Re: Bible Baptist Church-Special Land Use and Site Plan Review

Please find enclosed a revised project submittal for the Bible Baptist Church project. Included are revised site plans, a revised impact assessment, and an additional Special Use permit application for the encroachment in the 25' natural features setback.

UTILITY PLAN

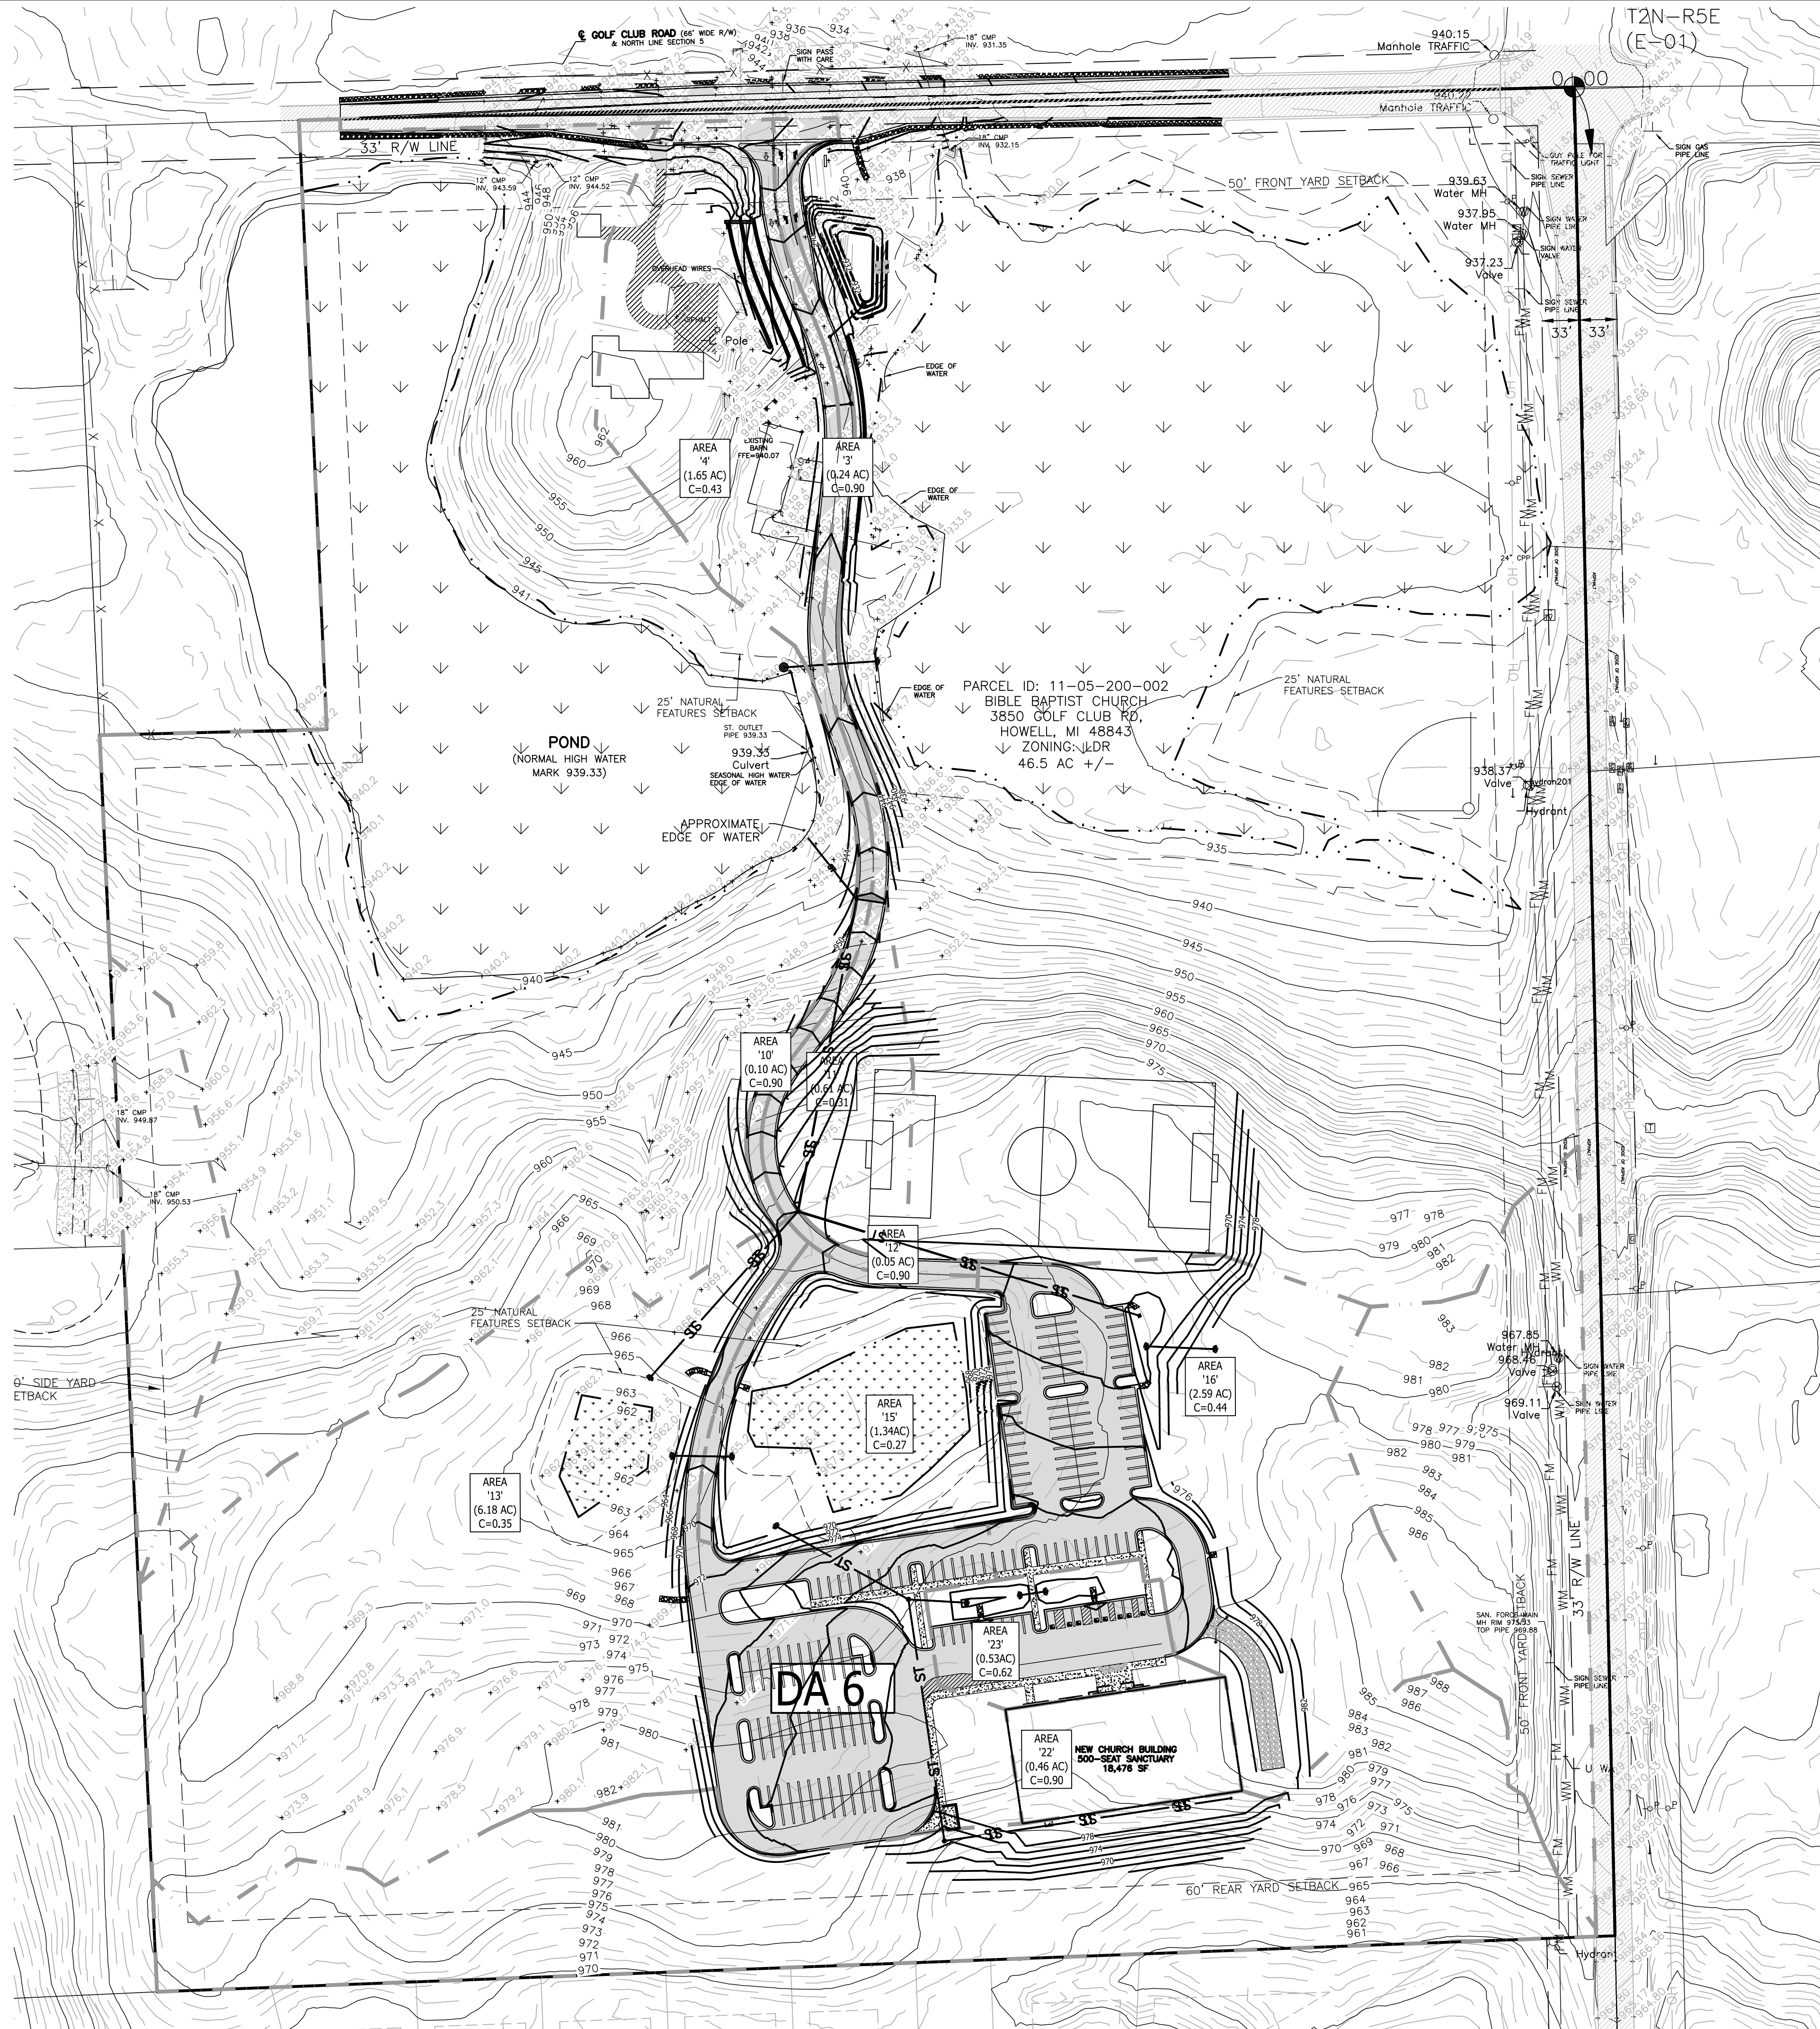
- 3) More detail has been added to the mechanical pretreatment structure detail as requested.
- 4) Storm Structure and pipe sizes have been added to the utility plan.

PROJECT: PHASE I BIBLE BAPTIST CHURCH CAMPUS
PREPARED FOR: BIBLE BAPTIST CHURCH
2258 EAST HIGHLAND ROAD
HOWELL, MI 48843
517-715-9233
TITLE: LANDSCAPE PLAN

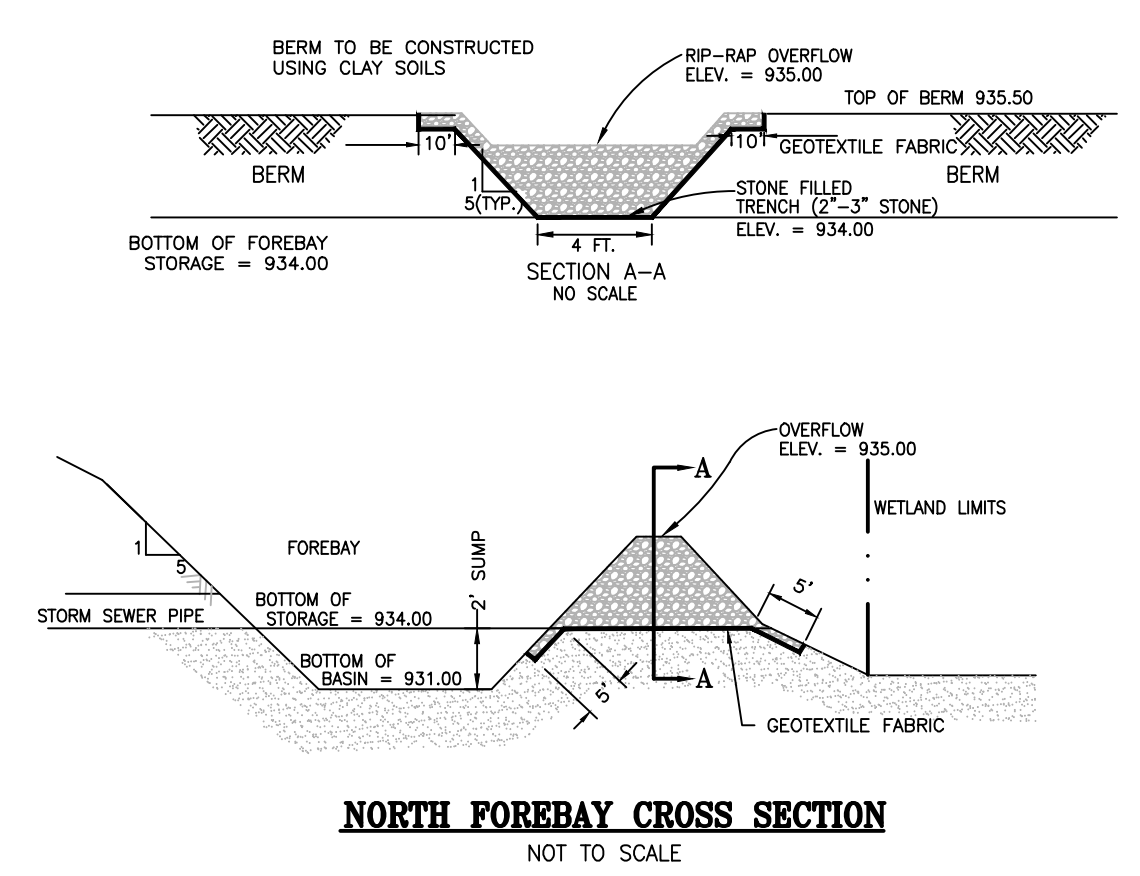
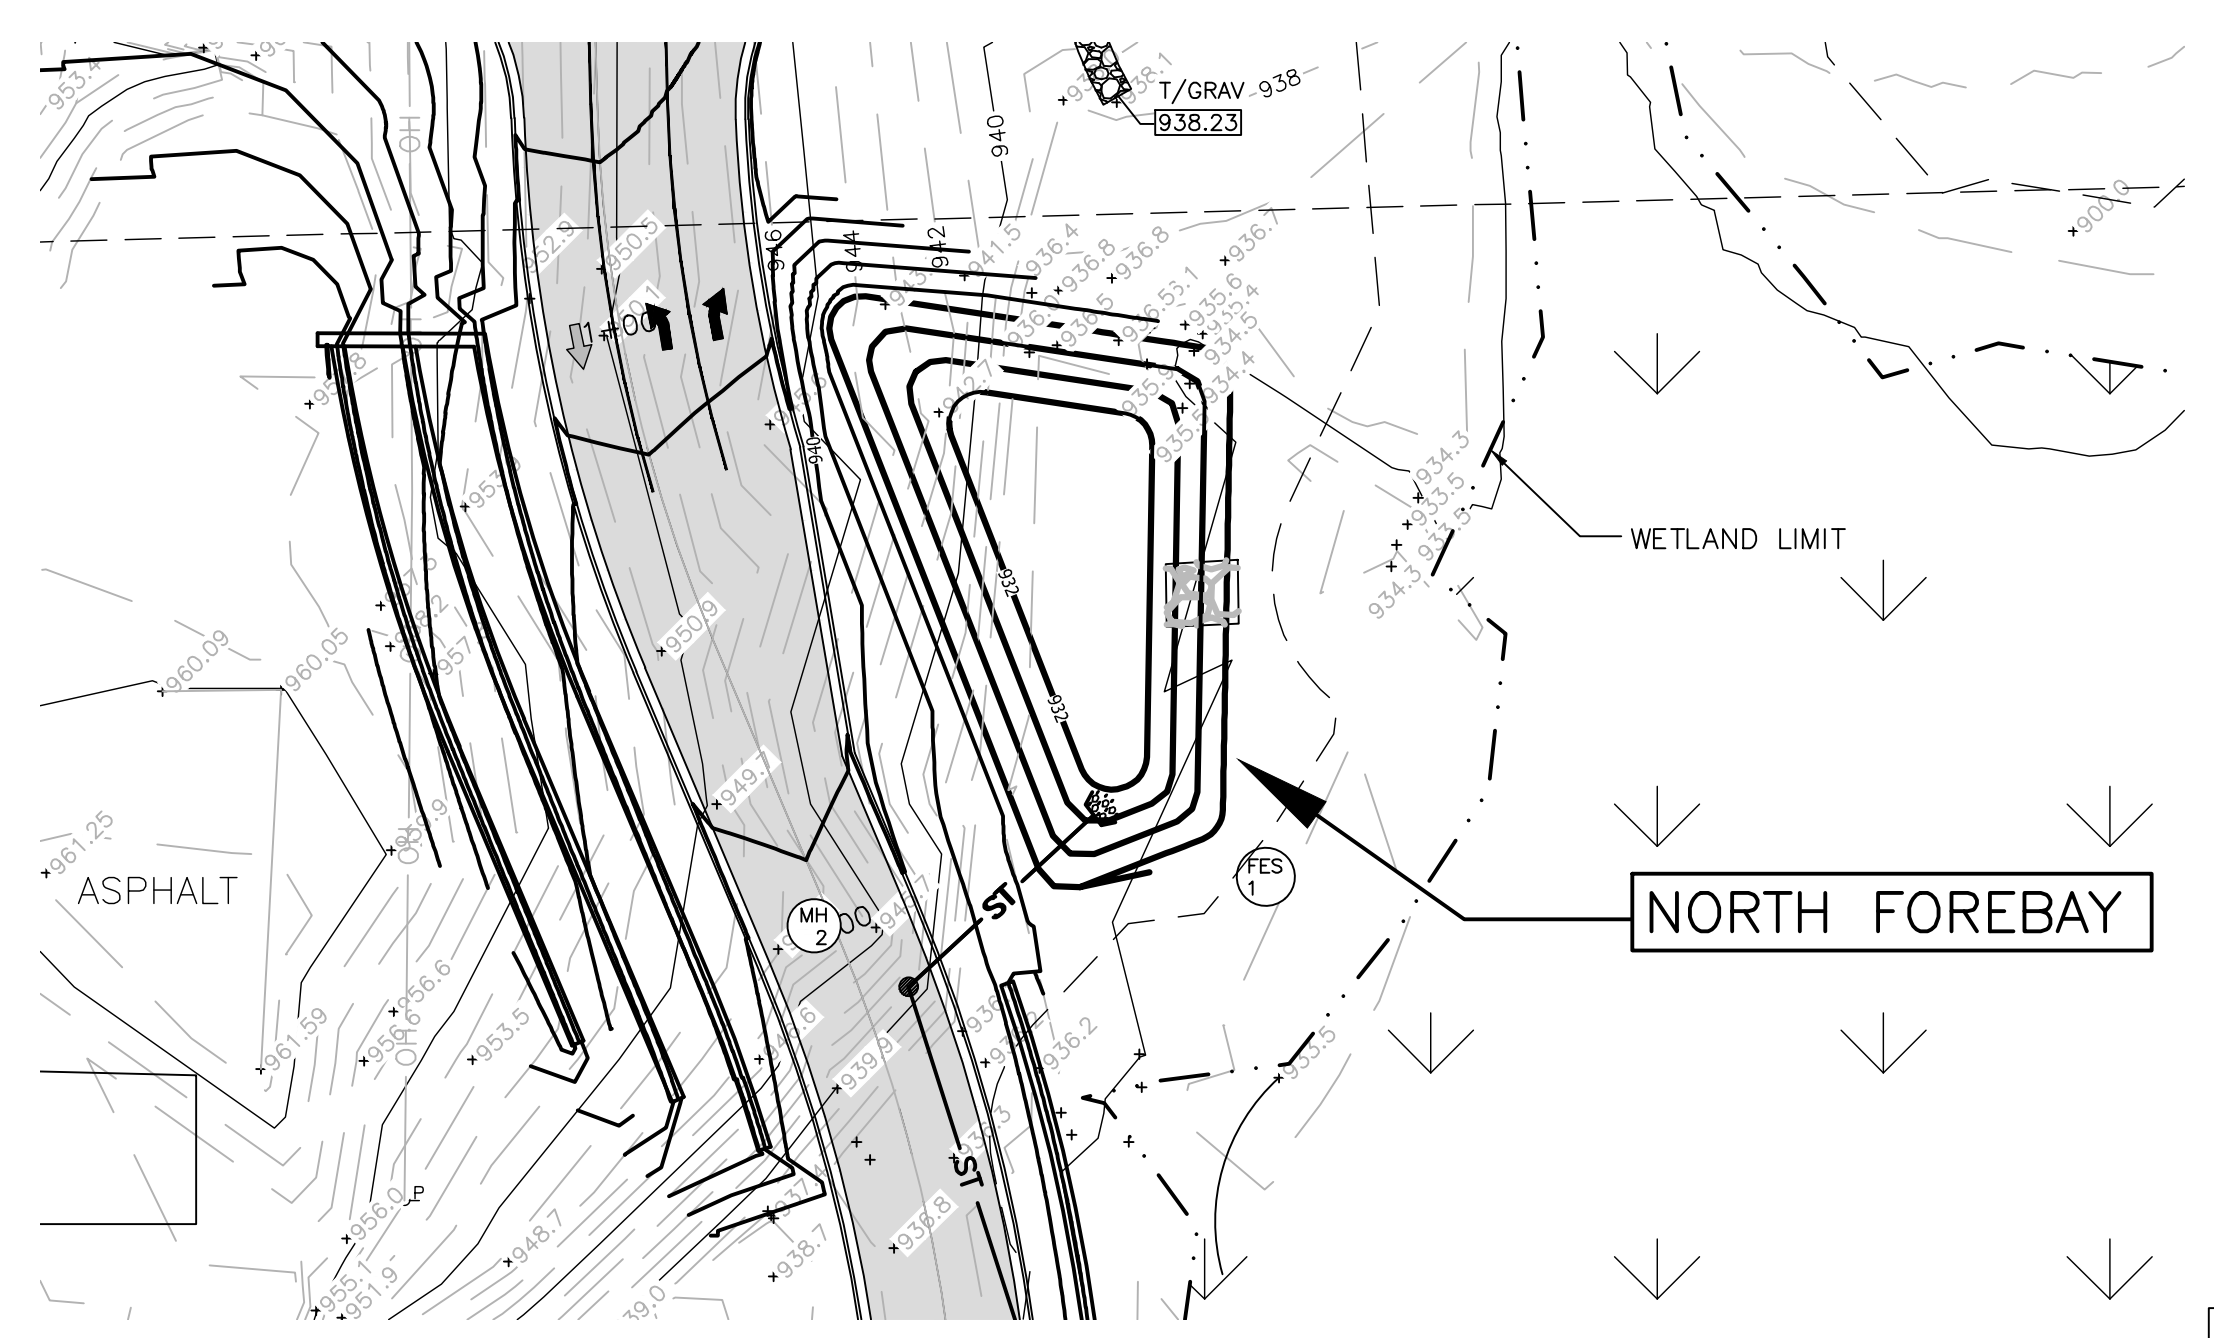
- 1) The landscape plans have been revised for the discrepancy at the north forebay and screening at the southern parking lot.
- 2) A note has been added to the plans indicating the site lighting shall be timer controlled to be off when no activities are occurring. We will note that we desire the site to be safe as well. So minimal site lighting, and maybe only the building lighting remains on for safety purposes.

- PARKING SETBACK: WHEREVER AN OFF-STREET PARKING AREA IS ADJACENT TO A RESIDENTIAL DISTRICT, THERE SHALL BE A MINIMUM PARKING LOT SETBACK OF 50 FEET WITH A CONTINUOUS OBSCURING WALL, FENCE AND/OR LANDSCAPED AREA AT LEAST 4 FEET IN HEIGHT SHALL BE PROVIDED. THE TOWNSHIP BOARD MAY REDUCE THIS BUFFER BASED ON THE PROVISION OF LANDSCAPING, THE PRESENCE OF EXISTING TREES OR IN CONSIDERATION OF TOPOGRAPHIC CONDITIONS.
PROVIDED: 36 SHRUBS PLANTED AT 4' TALL AT SOUTH EDGE OF PARKING LOT.

- REQUIRED: BUFFER TO MIXED USE PLD DISTRICT TO THE SOUTH.
PROVIDED: DENSE EXISTING 30'-60' WIDE BUFFER TO ADJACENT ZONING AT THE SOUTH WILL REMAIN. PLANTING ROW OF PLANTINGS ALONG THE SOUTHERN END OF THE SOUTHWEST PARKING LOT ADJACENT TO THE RESIDENTIAL TO THE SOUTH WHERE THE EXISTING VEGETATION REMAINING IS 30' WIDE.
